August 9, 2019

SUBJECT: Response to Design Management Zone Extension Request
Lemberger Fly Ash LF (SF NPL) and Lemberger Transport & Recycling Site (SF
NPL), Town of Franklin, Manitowoc County, Wisconsin
BRRTS #: 02-36-000112 and 02-36-000113

Figure 1 - Lemberger Fly Ash LF Parcel

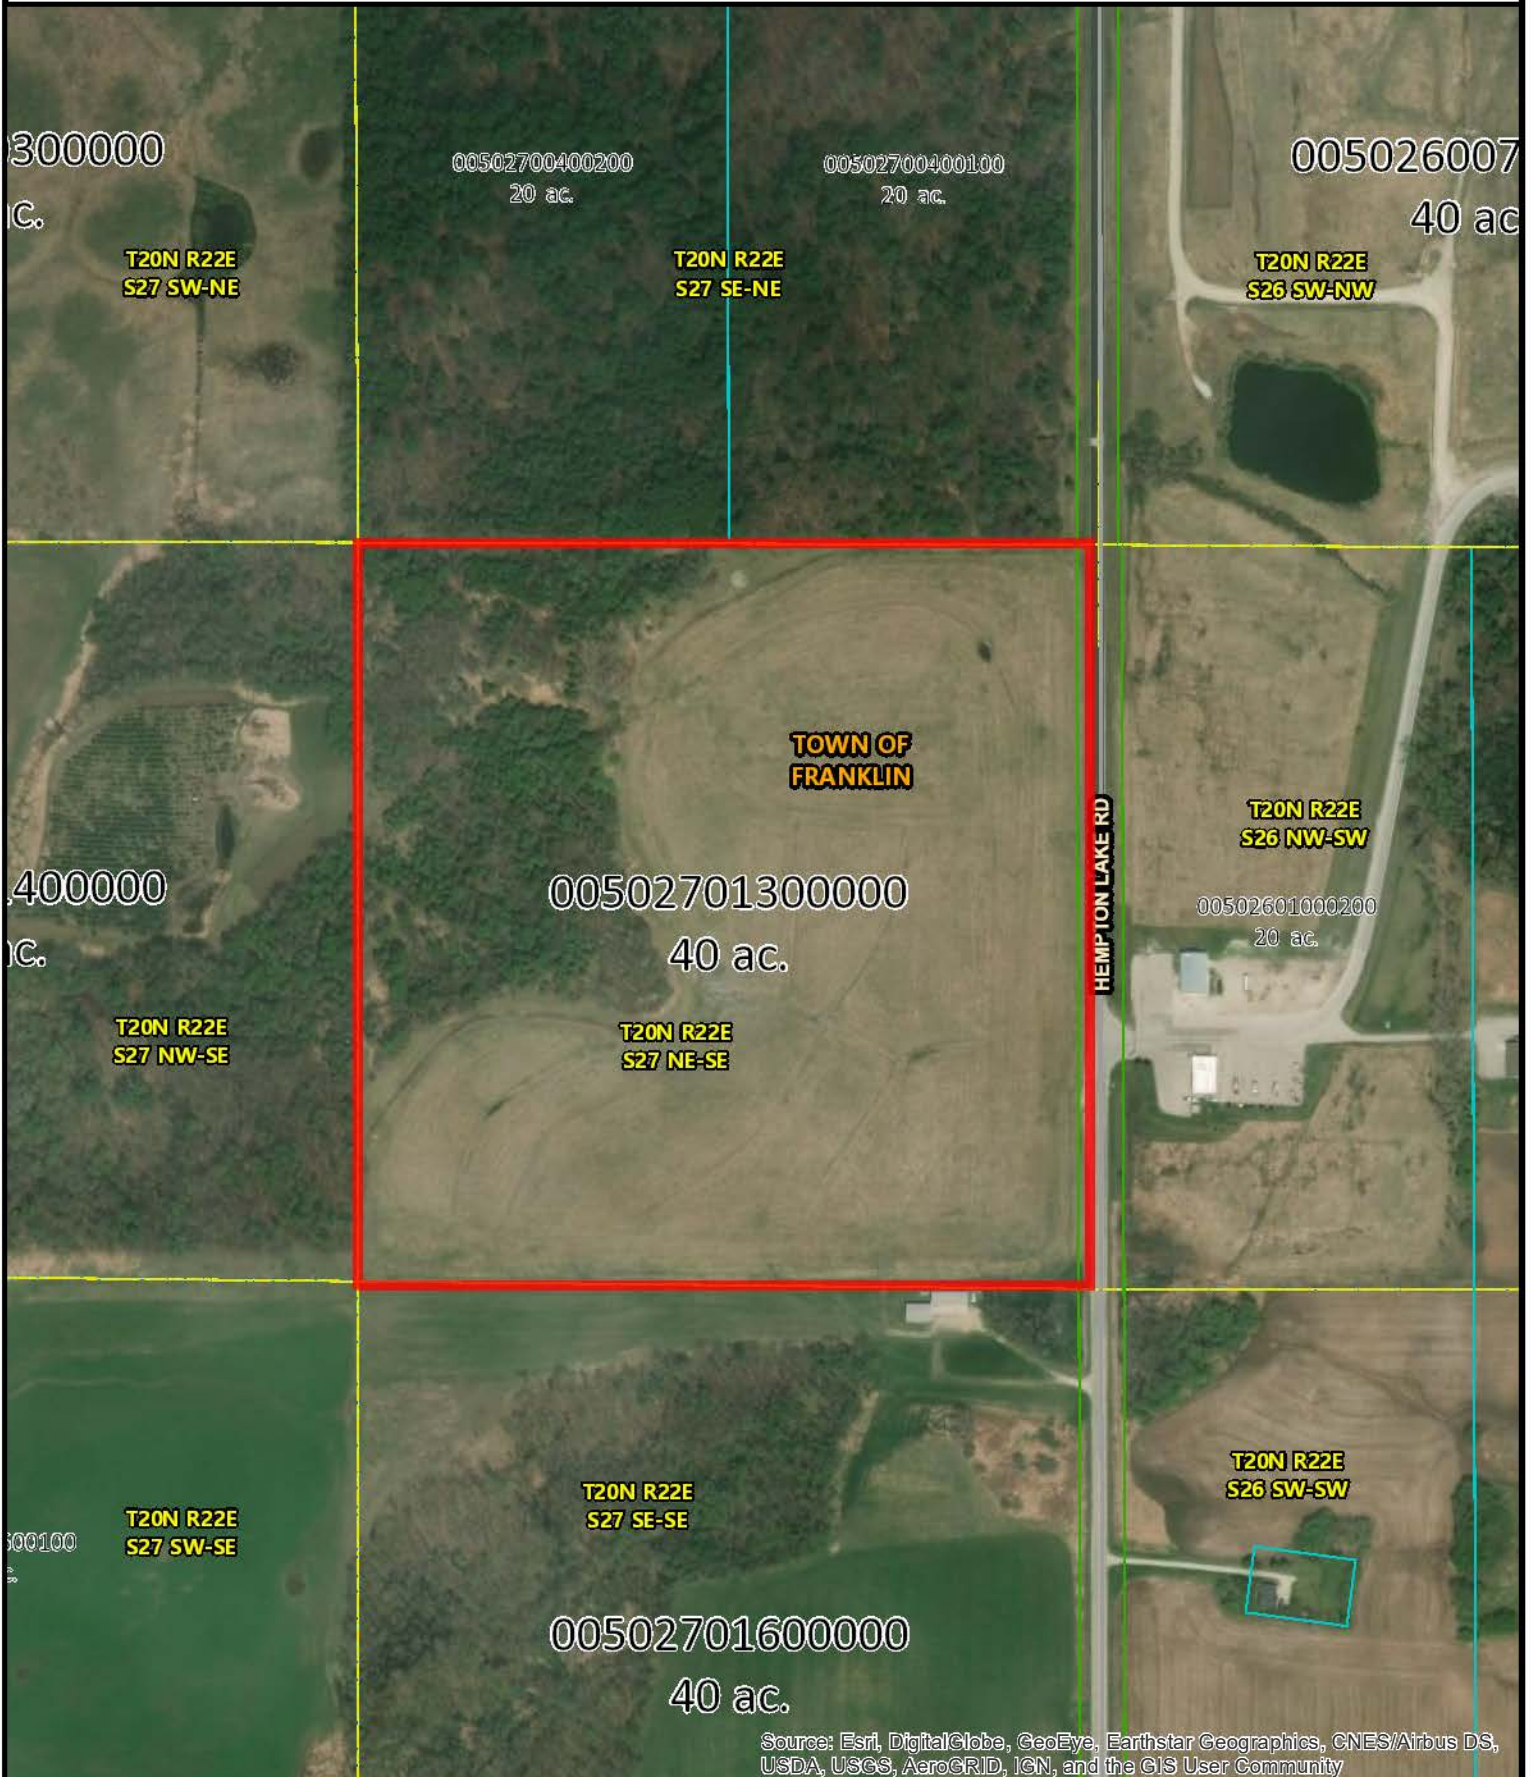
The Lemberger Fly Ash landfill site is comprised of one parcel (parcel # 005-027-013-000.00) and the Lemberger Transport & Recycling landfill site is comprised of four contiguous parcels (parcel #s 005-034-003-000.00, 005-034-002-001.00, 005-034-001-000.00, and 005-034-004-003.00) as depicted on attached Figures 1 and 2. A DMZ may be established in accordance with Table 4 of Wis. Adm. Code § NR 140.22 within the property boundaries; however, if the horizontal distance of the DMZ boundary to the waste limits is further than the horizontal distance of the property boundary to the waste limits, then the property boundary is established as the compliance boundary for meeting the enforcement standards. Based on the current property ownership and configuration of the landfill waste limits, the

DNR has concluded that a DMZ of 300 feet and/or an extension of 450 feet are beyond the current property boundaries of both landfills. Therefore, the compliance boundary for meeting the enforcement standards are the current property boundaries.

To use the horizontal distance of 300 feet for the DMZ in Table 4 of Wis. Adm. Code § 140.22, the LSRG would have to gain control of surrounding parcels either through lease or ownership to expand the contiguous parcel of land around each landfill. If this is completed, then the 300 feet horizontal distance could be used as long as it is within the newly established property boundaries. Since the definition of property boundary considers land contiguous even if a public or private road runs through the parcel, the fact that Sunny Slope Road would be running through any newly established parcel for the Lemberger Transport & Recycling landfill site, it would have no impact on the DMZ. To request to extend the horizontal distance to 450 feet for the DMZ, the above would need to apply in addition to meeting the requirements in Wis. Adm. Code § NR 140.22(3)(b), (c), and (d).
